PROOF OF EVIDENCE

Landscape and Visual Matters

at Land Rear of High Street, Colney Heath

PINS Ref: APP/C1950/W/23/3333685

Image 3: Extract from Figure 4 – Zone of Visual Influence taken from TLVIA; showing locations of viewpoints outside of the area identified as having visual influence

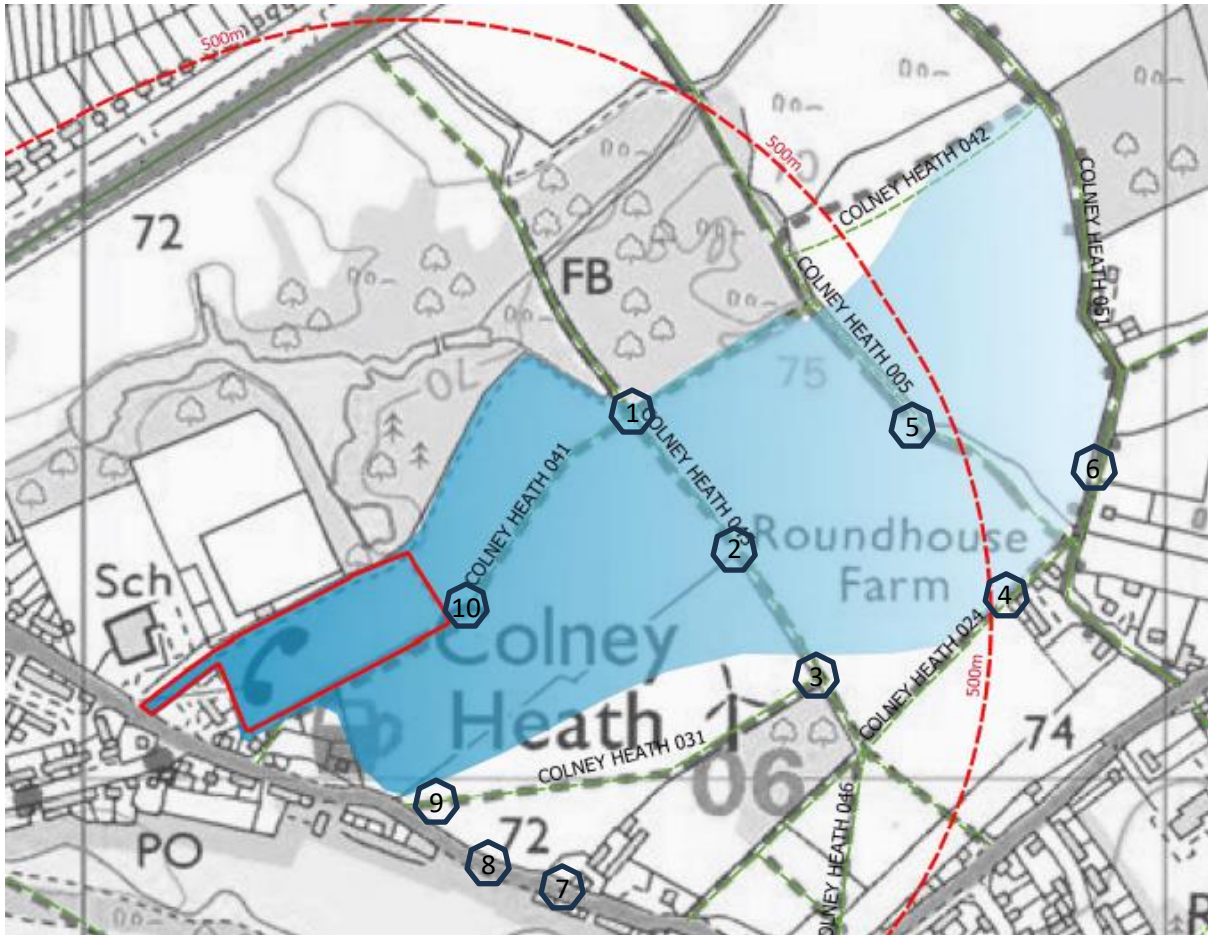
- 5.1.7 This is relevant because during my site visit, I found that the site is visible from areas that sit outside the areas identified within the ZVI, such as along footpath 031 and footpath 045 where it meets 031. These viewpoints are in the short to mid range however rather than being more distant as is noted at sentence 3 of paragraph 5.2. These views are illustrated as viewpoints 3 and 9 in the images I provide in this document in Chapter 6.0 to help identify the effects of change.

- 5.1.8 As can be seen, viewpoints 3, 7, 8 and 9 sit outside of the area highlighted by the ZVI, along with the remainder that sit within the area identified as having intervisibility with the site.
- 5.1.9 There would of course also be a substantial effect on the residents that sit close to the site that should be acknowledged.
